February 28, 2023

Subject: Review of Plans and Response to Geotechnical Review Comments Proposed New Residence 6950 Southeast Maker Street Mercer Island, Washington

Reference: Geotechnical Engineering Study, same project; Geotech Consultants, Inc.; March 21, 2022.

Seismic

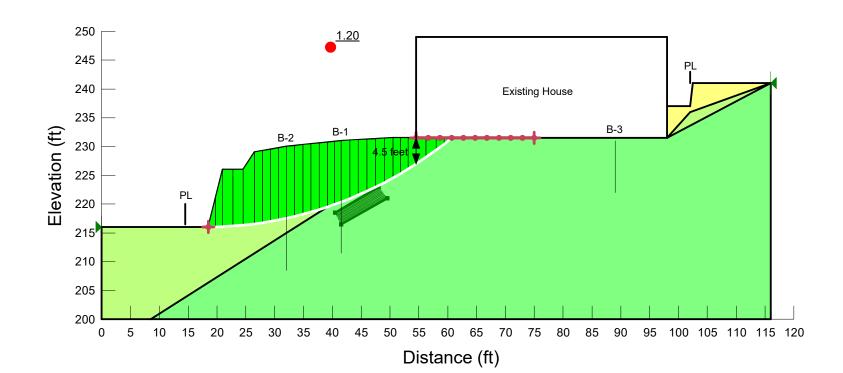
Updated Slope Stability Analyses: Attached to this letter are the results of our slope stability analyses through the residence and the western yard and manmade steep slope. For our analyses, we utilized the peak ground motions of the Maximum Considered Earthquake, which has a probability of occurring once in 2,475-years.

Not surprisingly, the slope stability analyses confirmed that a deep failure would not extend into the competent glacial till underneath the proposed residence in the worst case scenario (during a seismic event). At the western extent of your planned house, which is essentially the same as the west edge of the existing residence, the theoretical critical failure surface would extend only 4.5 feet below the existing grade.

Based on the provided drawings, the basement floor for your new residence has a finish floor elevation of 226.47 feet, which is 4 feet below the existing grade. The western footing for the new house will be bottomed at least 12 inches below the finish floor elevation, based on the Foundation Plan (sheet S2.0) and detail 101/S1.1. As a result, as a minimum, the western footing of the new house will bear below the critical slope stability failure surface. In addition, this footing (as well as the remainder of the house) will bear directly on competent glacial till that is not susceptible to instability.

Considering the above discussion, the residence will be protected against being undermined by a theoretical slope failure in the event of the low-probability Maximum Considered Earthquake. No additional mitigation measures are needed to protect your house for the design seismic event.
